# **Post Accident AP1000 Containment Leakage**

## **An Unreviewed Safety Issue**

**Fairewinds Associates, Inc, April 21, 2010**

A Report by Arnold Gundersen, April 21, 2010  
Chief Engineer, Fairewinds Associates, Inc

- Figure 1 – AP1000 in normal operation.
- Figure 2 – AP1000 design basis accident begins.
- Figure 3 – AP1000 containment hole opens as containment fills with radioactive gases.
- Figure 4 – AP1000 chimney effect draws radioactivity directly into the environment.

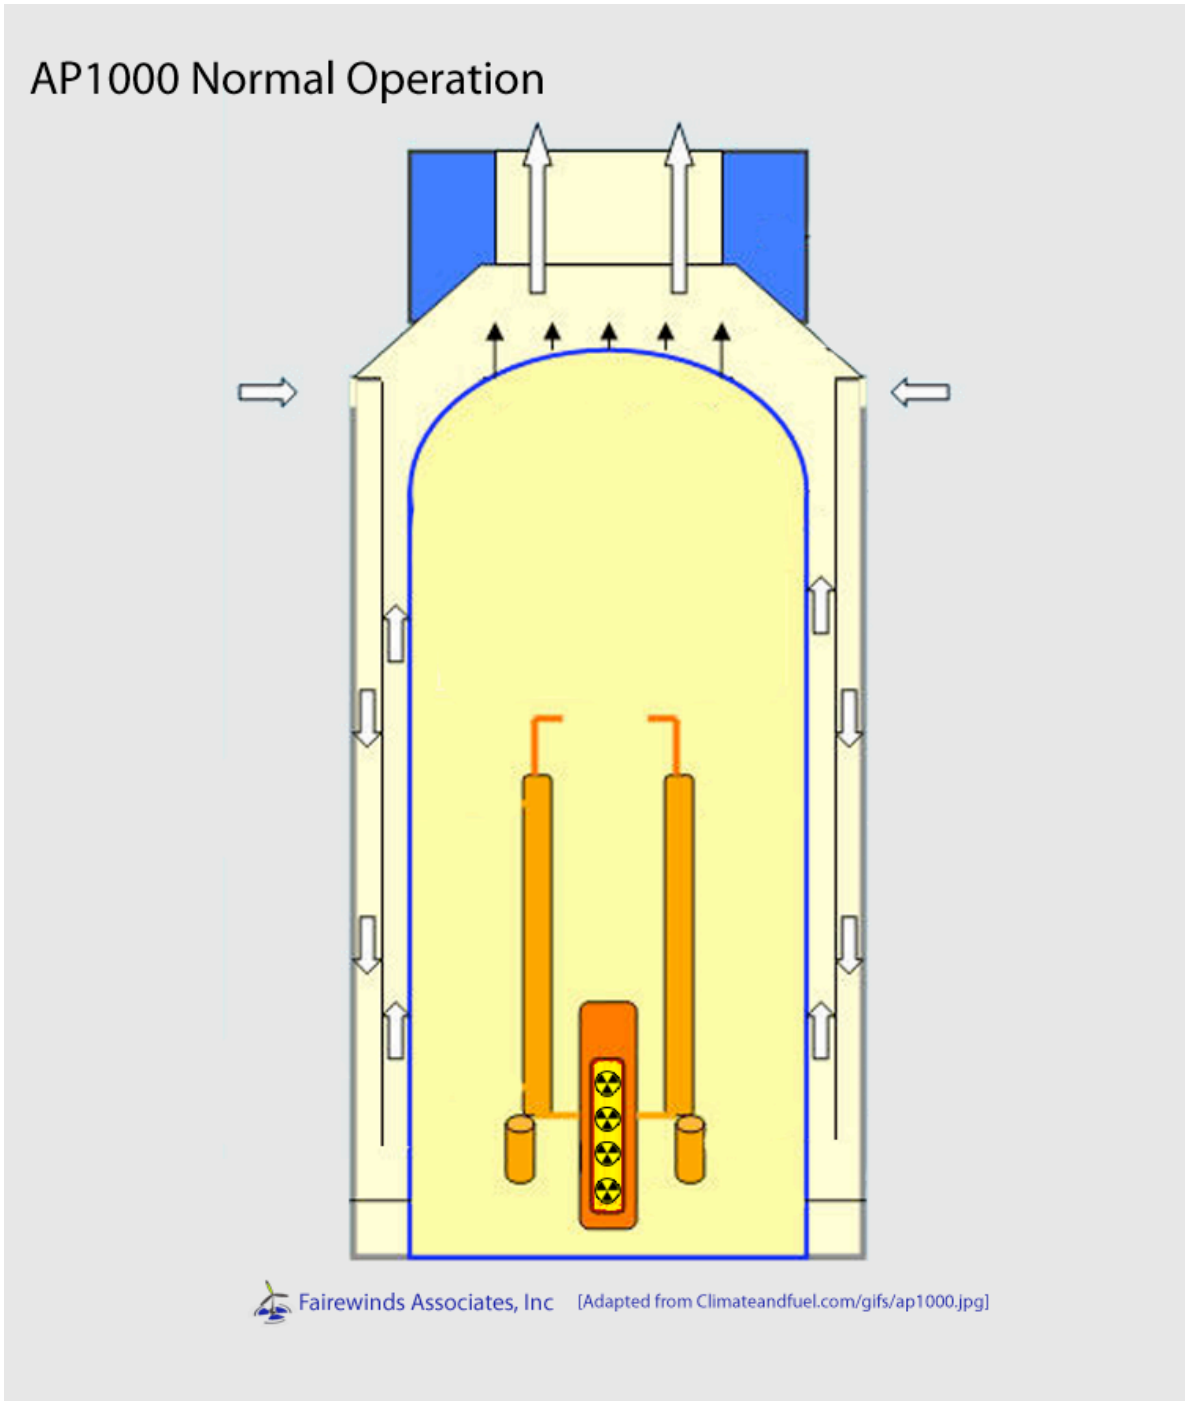
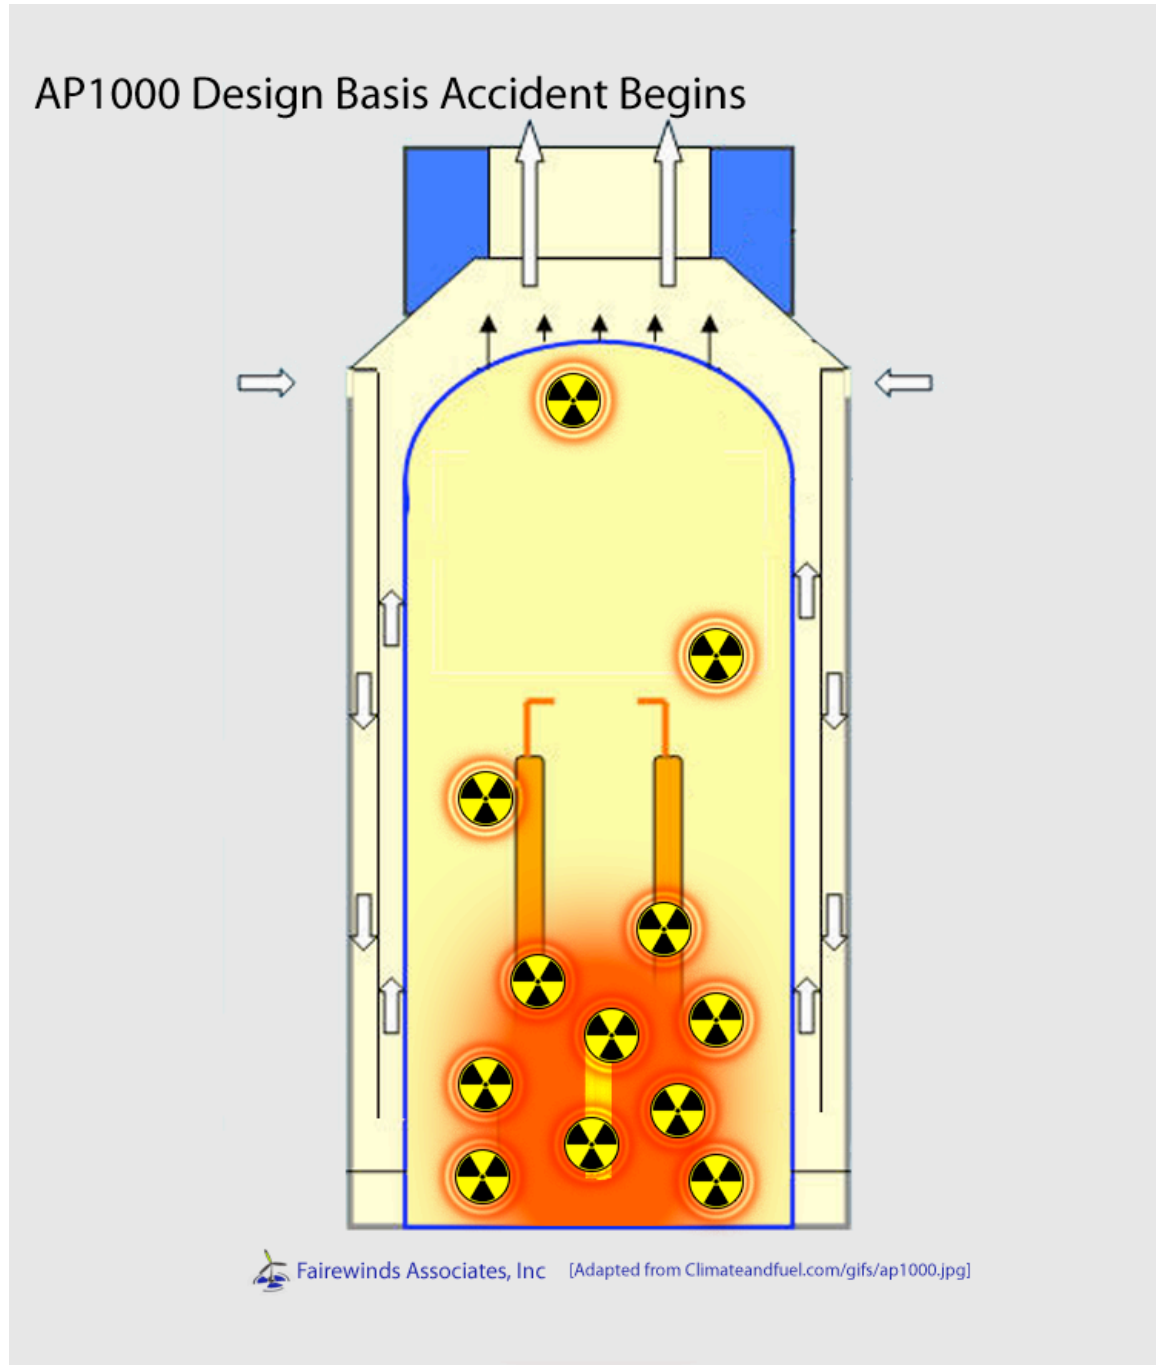
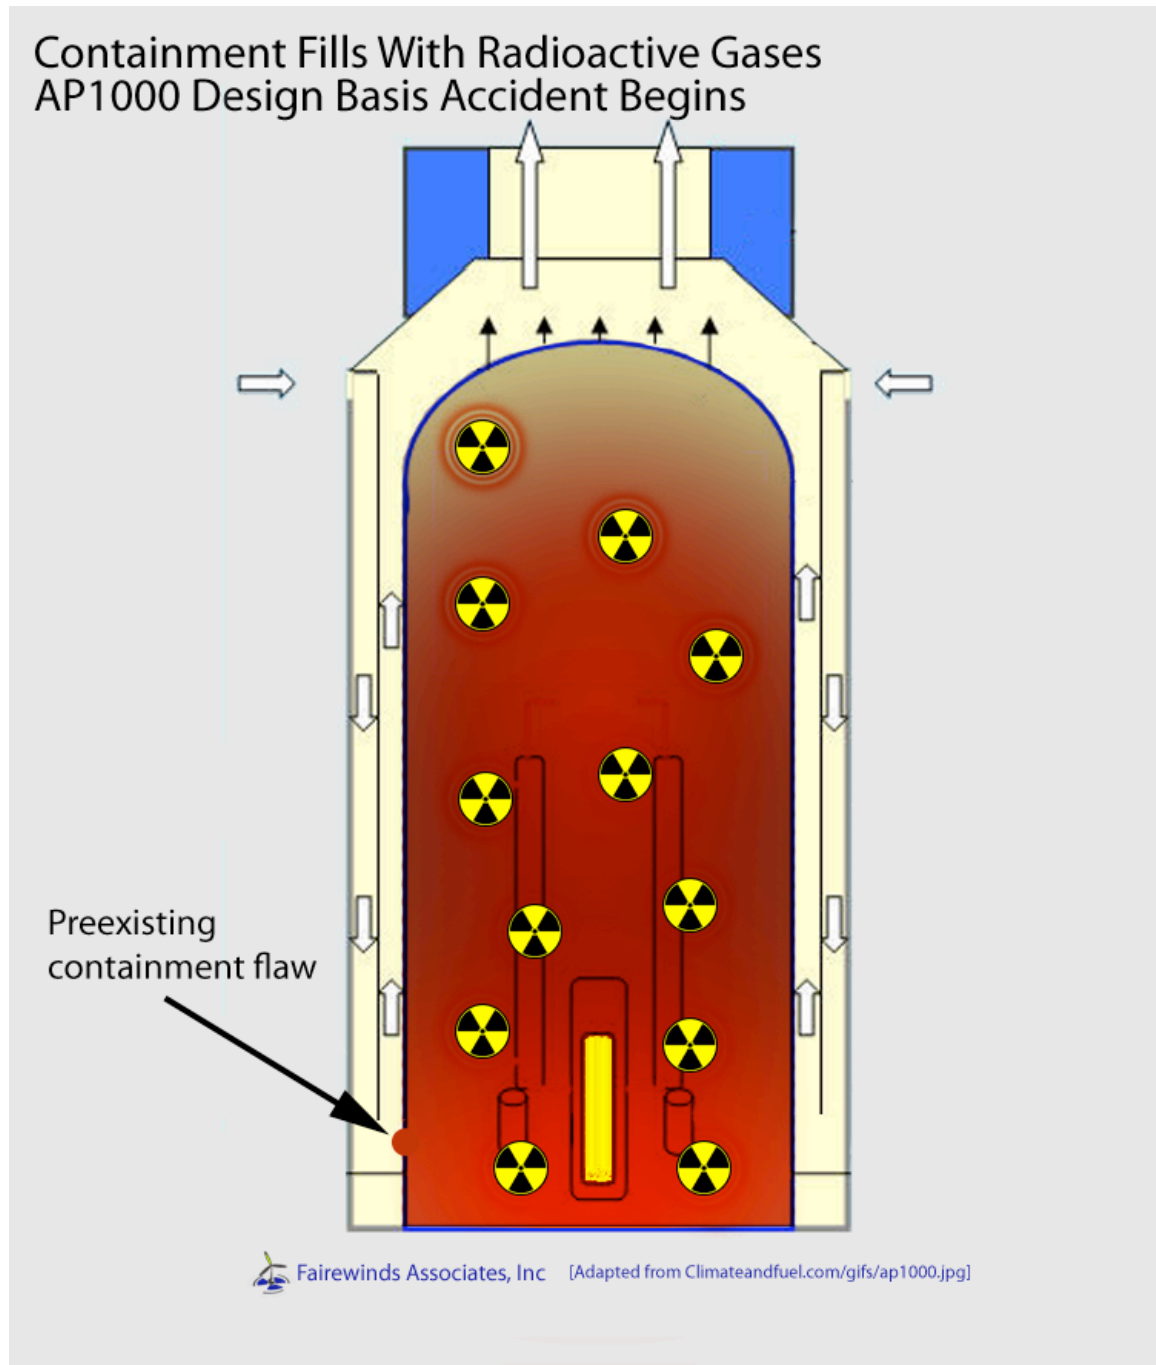
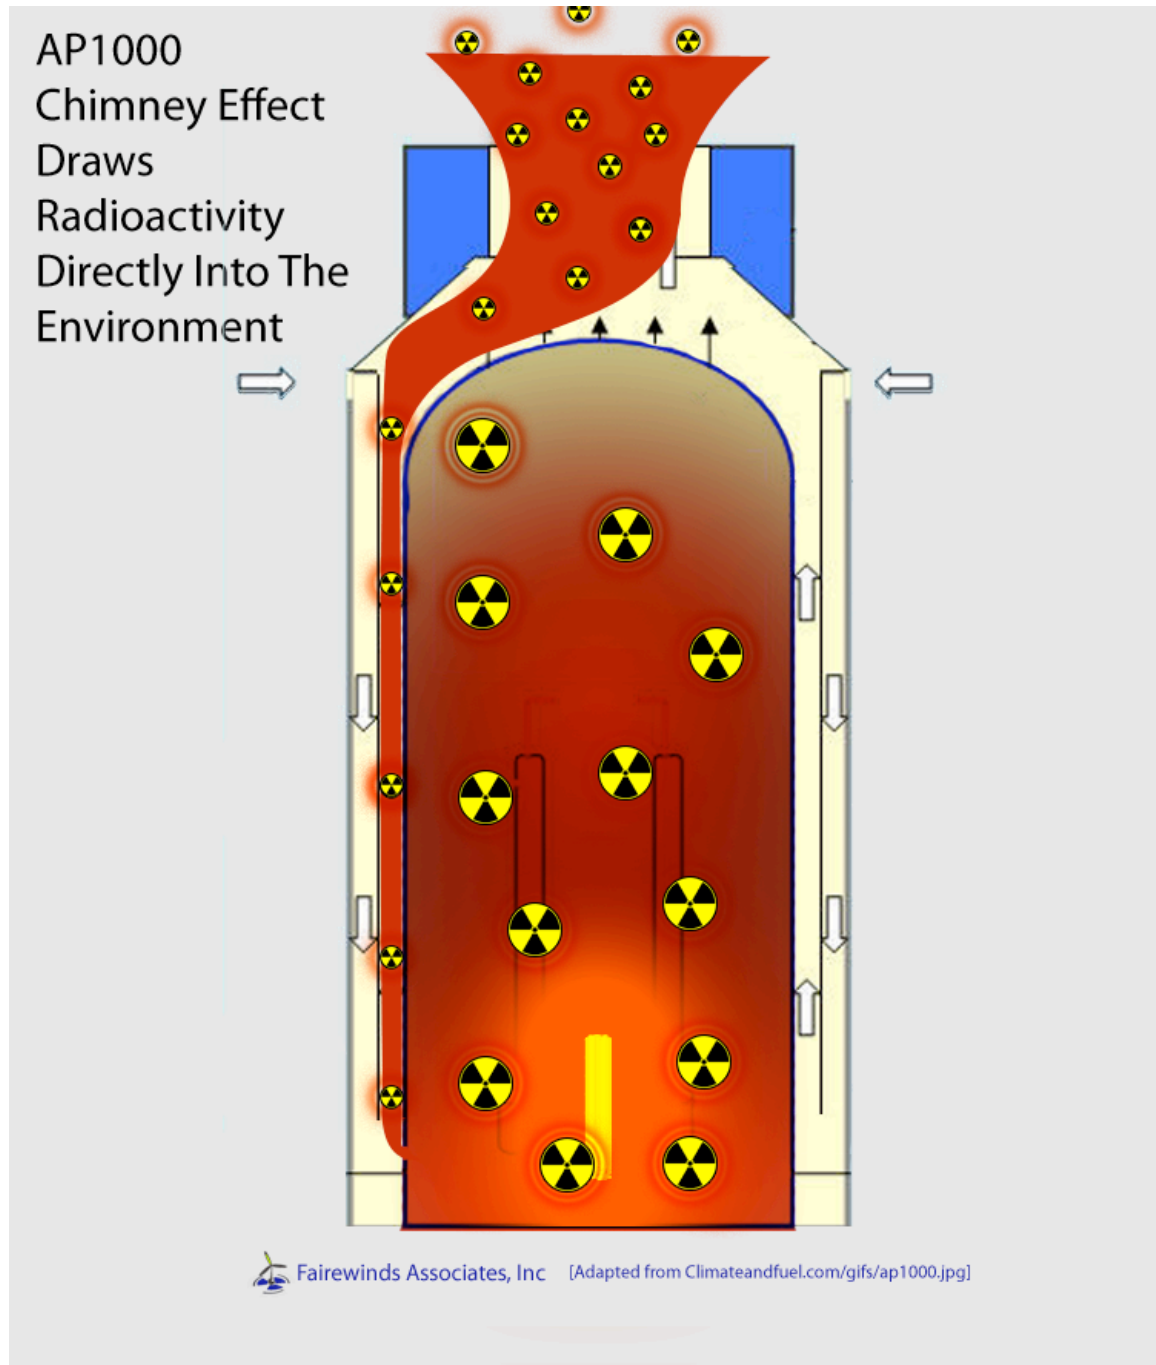
Given that moisture and corrosive chemicals will be drawn into the gap between the shield building and the containment and that various welded connections will provide locations for pit and crevasse corrosion to initiate, it is possible that intergranular corrosion in weldments could propagate at a rate of 0.15 inches per year or faster, and in locations that are under stress, cracks could form. In my opinion a small crack could create a hole that would remain undetected and completely penetrate the AP1000 containment in a through-wall leak within approximately ten years or less.
